**Technical TPP  
Field Change Notes**

**Updated 27th December 1994**

TPP Field Change Notice no. 80

Product ..... : DDE800 Wyse-370

Figure 1

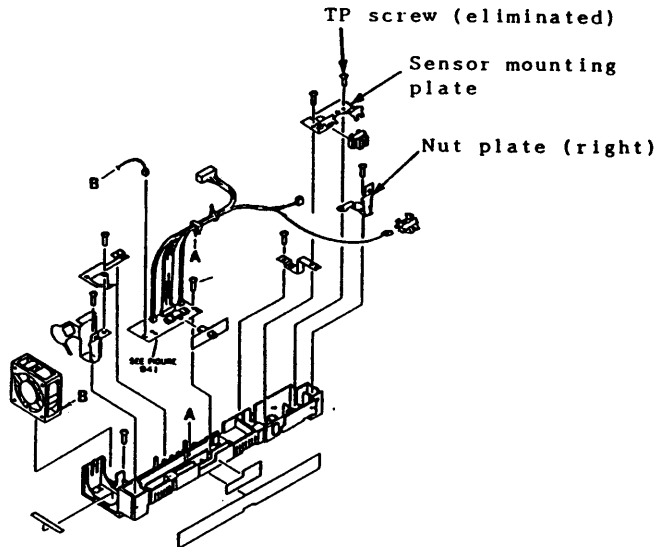
The sensor mounting plate and right nut plate (figure 1) have been combined. Along with this change, a TP screw has been eliminated.

**Figure 1**

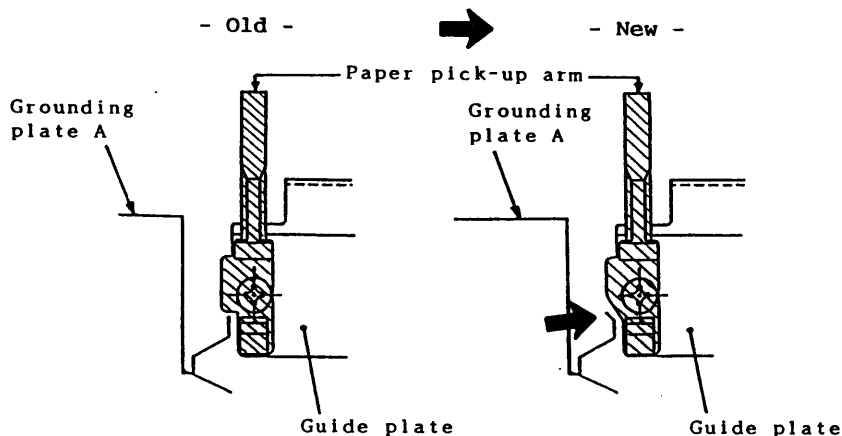
To prevent this, the paper pick-up arm and grounding plate A have been modified. Refer to figure 1.

Figure 1

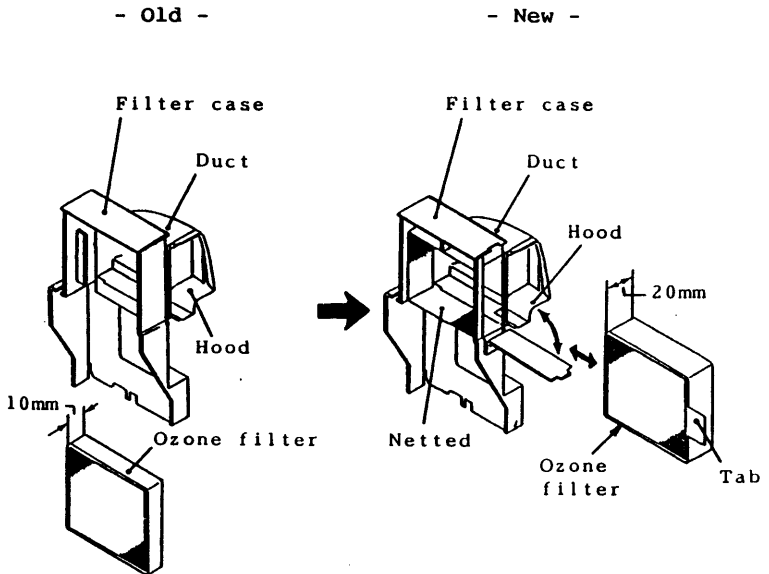
To reduce ozone emission, the ozone filter has been changed. Along with this change the ozone filter case, duct and hood have been modified, so that the ozone filter can easily be replaced. Refer to figure 1.

Figure 1

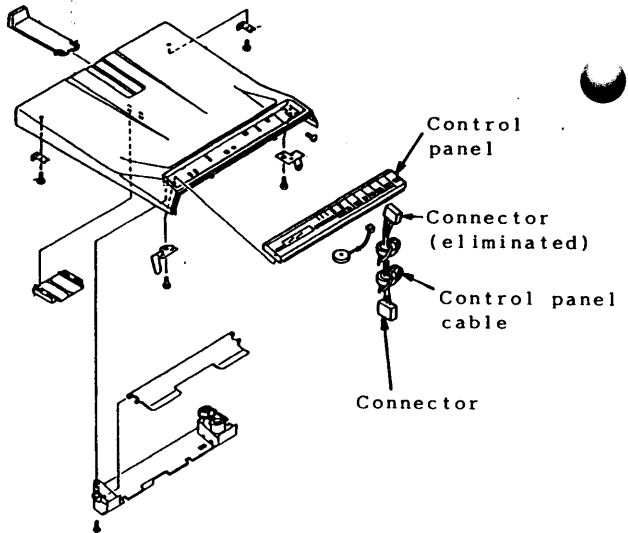
The control panel cable is now directly soldered to the Control Panel P.C. Board.  
The cable is, therefore, no longer available as a separate service spare part. Refer to figure 1.

**Figure 1**

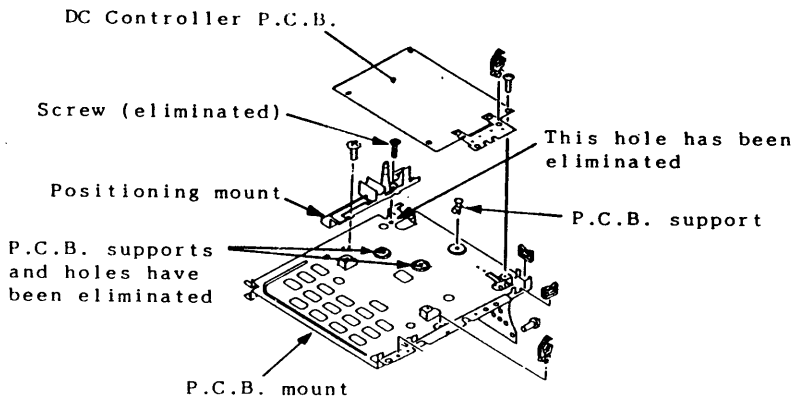
Two of the three P.C.B. supports for the DC Controller P.C. Board have been eliminated. Along with this, the two holes for these P.C.B. supports in the P.C.B. mount have also been eliminated. Refer to figure 1.
